CITY OF SANTA FE

Planning and Land Use Department Planning Commission Staff Report

Case No: 2024-8195

Proposal: Development Plan approval for an all-suite hotel for 46 suites on 2.01 acres.

Figure 6: Landscaping Plan

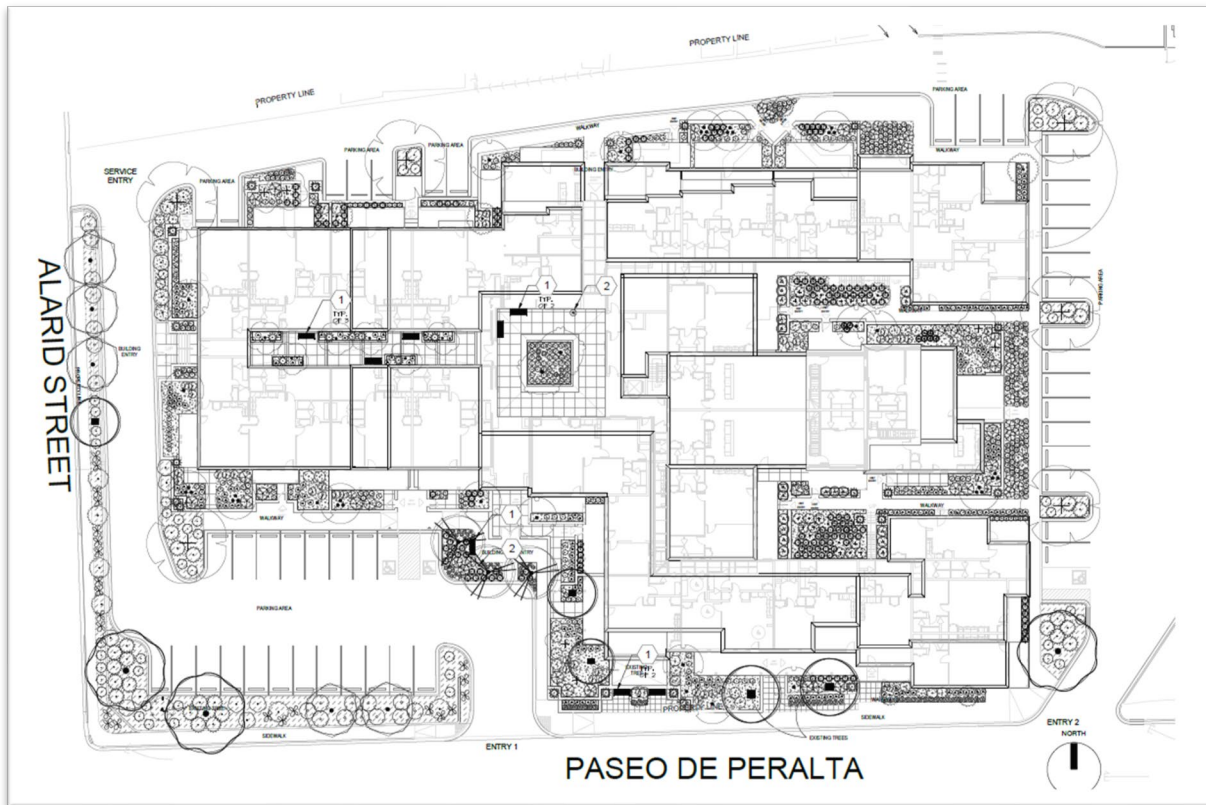
The Applicant is proposing landscaping throughout the Project. Along Alarid Street, the neighborhood edge, the Project includes a landscaping buffer of five feet with trees and shrubs between the sidewalk and yard wall. Immediately next to the landscaping is a five-foot-tall coyote fence, see Figure 6: *Landscaping Plan*. The proposed landscaping is in conformance with the requirements in the Master Plan.

However, Staff’s review has found that the landscape plan requires technical corrections (see Attachment A “*Conditions of Approval and Technical Corrections*”). The technical corrections must be addressed prior to the recordation of the Project. All terrain management and technical review conditions of approval and technical corrections can be found in Attachment A “*Conditions of Approval and Technical Corrections*” and in Attachment B “*DRT Memos*.”
